# **REQUEST FOR PROPOSALS**

**To Design and Construct  
I-65 Southeast Indiana Project  
Through a Public Private Agreement**

## **VOLUME II TECHNICAL PROVISIONS**

**A Project of the  
INDIANA DEPARTMENT OF TRANSPORTATION  
ISSUED DECEMBER 28, 2016  
ADDENDUM 4 ISSUED MARCH 24, 2017**

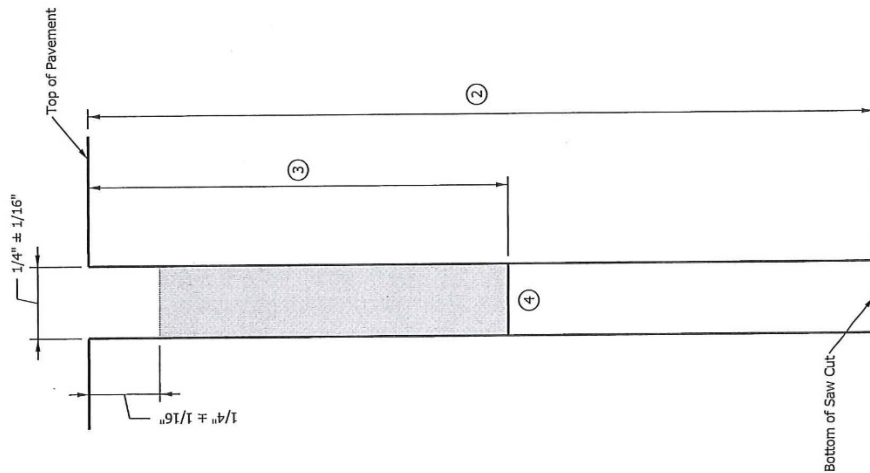
SECTION 503, BEGIN LINE 78, DELETE AND INSERT AS FOLLOWS:

construction traffic uses the PCCP prior to sealing. *The sawed joint shall be cleaned as specified in 503 05(a)*

1. This detail is to be used in place of Standard Drawing E 503-CCPJ-03.
- ② For Longitudinal Joint per 503.03(b), the depth of saw cut shall be D/3 (-0.43/8"). "D" is identified on Standard Drawing E 503-CCPJ-01 and -02. For Longitudinal Construction Joint per 503.03(d), the depth of saw cut shall be 1".
- ③ For Longitudinal Joint per 503.03(b), the depth of sealant shall be at least 2". For Longitudinal Construction Joint the sealant shall go to the bottom of the 1" saw cut.
- ④ A backer rod shall not be installed.

**TYPE D-1 SAWED CONTRACTION JOINT SEALANT**

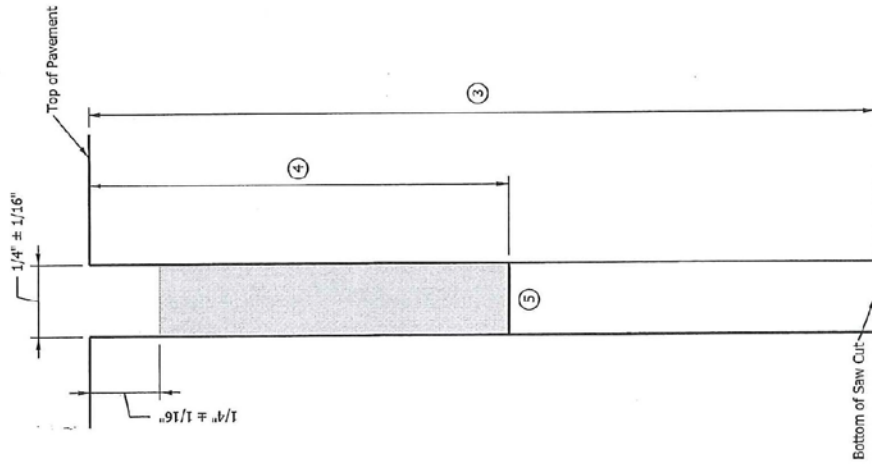
1. This detail is to be used in place of Standard Drawing E 503-CCPJ-06.
2. Transverse joints shall be constructed perpendicular to the centerline with maximum spacing of 18'-0" unless otherwise specified.
- ③ The depth of the saw cut shall be D/3 (-0, +3/8") "D" is defined on Standard Drawing E 503-CCPJ-01 and -02.
- ④ The depth of sealant shall be at least 2".
- ⑤ A backer rod shall not be installed.
